CHARLOTTE - MECKLENBURG Planning Commission

DATE:	June 18, 2008
то:	Gary Huss Zoning Coordinator	FROM:	Debra Campbell Planning Director

SUBJECT: Administrative Approval for Petition No. 2007-82 by Pope & Land Enterprises Attached are revised plans for the above petition. The plans have been revised to make minor changes to Le layout of the future roadways and to allow additional private streets. Since these changes are minor and does not alter the intent of the development and meet the requirements of the Charlotte Zoning Ordinance Section 6.207 Alterations to Approval, minor changes, I am administratively approving these plans. Please use these plans when evaluating requests for building permit and certificates of occupancy. Note all other ordinance requirements still apply.

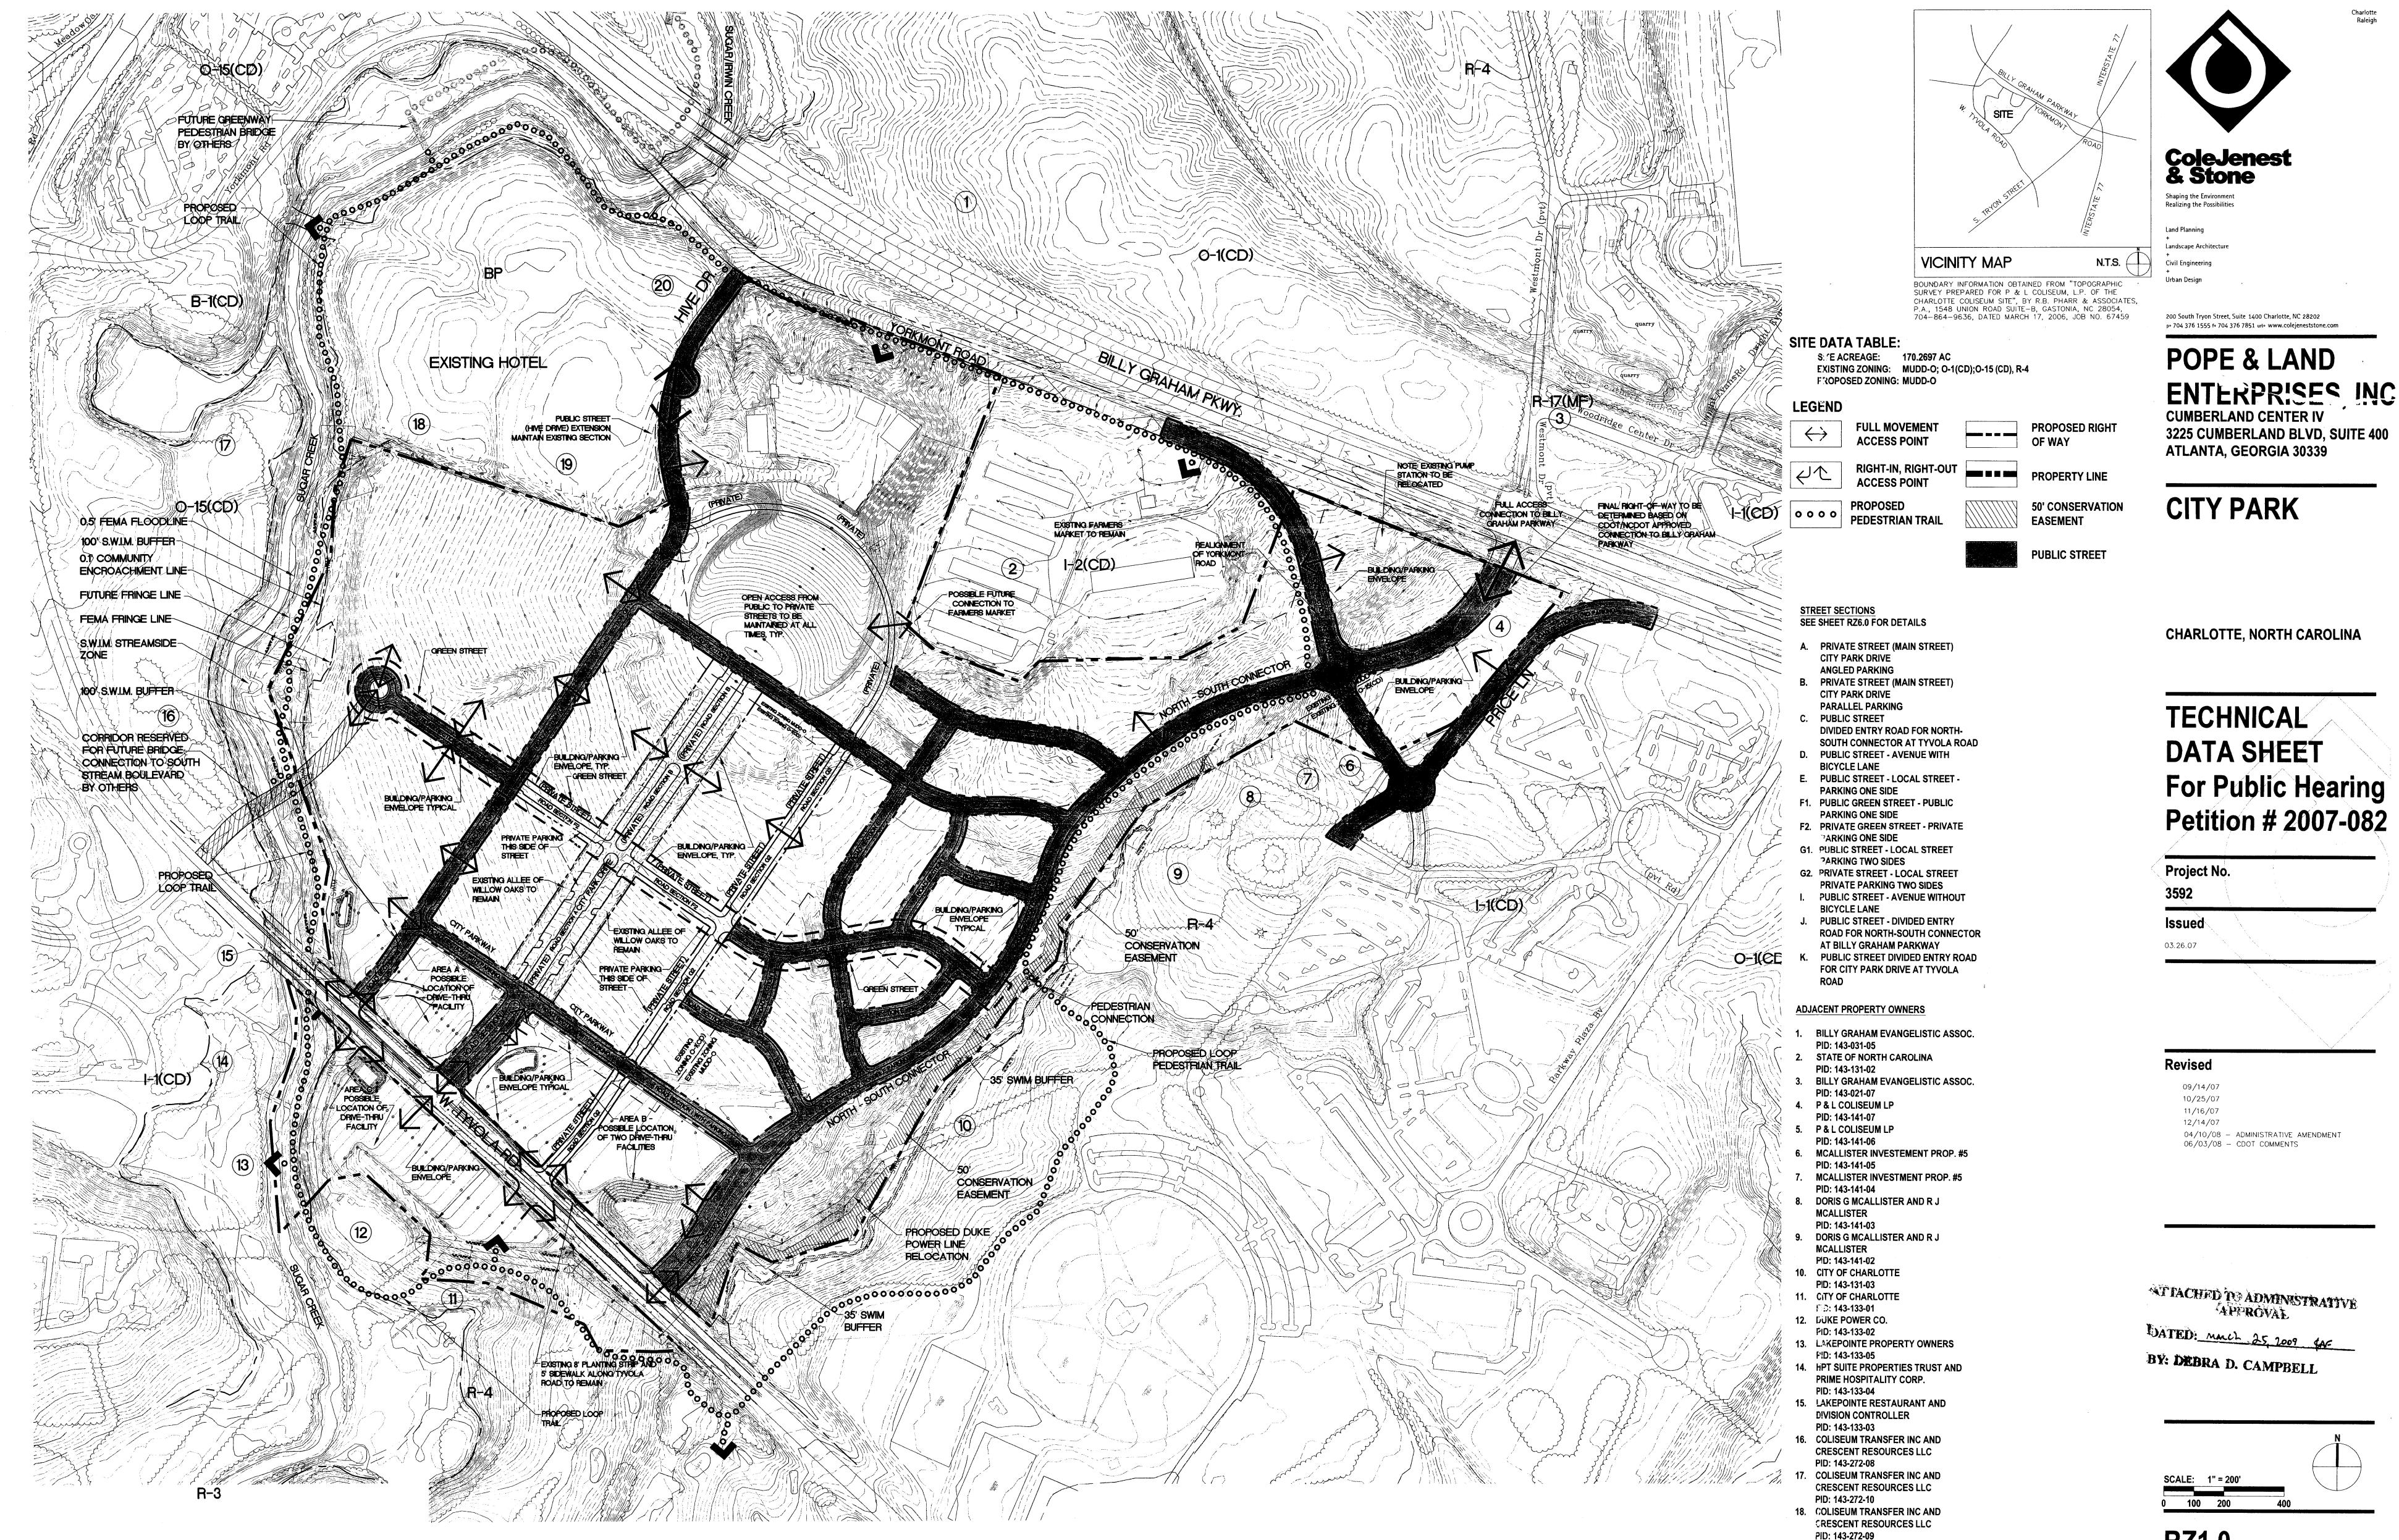
Attached are the revised site plans for the above petition. The plans have been revised to update the conditional stormwater note. Since this note does not alter the intent of the development, I am administratively approving this conditional note. Please use this plan when evaluating requests for building permits and certificates of occupancy.

STORM WATER RUNOFF WILL BE MANAGED THROUGH PROVEN TECHNIQUES WHICH SATISFY THE STANDARDS IMPOSED BY THE CITY OF CHARLOTTE ORDINANCES AND THE CHARLOTTE MECKLENBURG STORM WATER DESIGN MANUAL IN PLACE AT THE TIME THIS REZONING PETITION WAS FILED, EXCEPT AS MODIFIED BELOW. WHERE REQUIRED, SURFACE LEVEL STORM WATER DETENTION MAY BE LOCATED IN COMMON OPEN SPACE AREAS BUT NOT WITHIN SETBACK OR S.W.I.M. BUFFER AREAS. SPECIFICALLY, THE PETITIONER SHALL PROVIDE FOR THE FOLLOWING BASED ON THE DRAINAGE BASINS IDENTIFIED ON THE SUPPLEMENTAL DATA SHEET (RZ5.0), AS WELL AS THE ATTACHED SUPPLEMENTAL DRAINAGE BASIN EXHIBIT DATED 02/18/09:
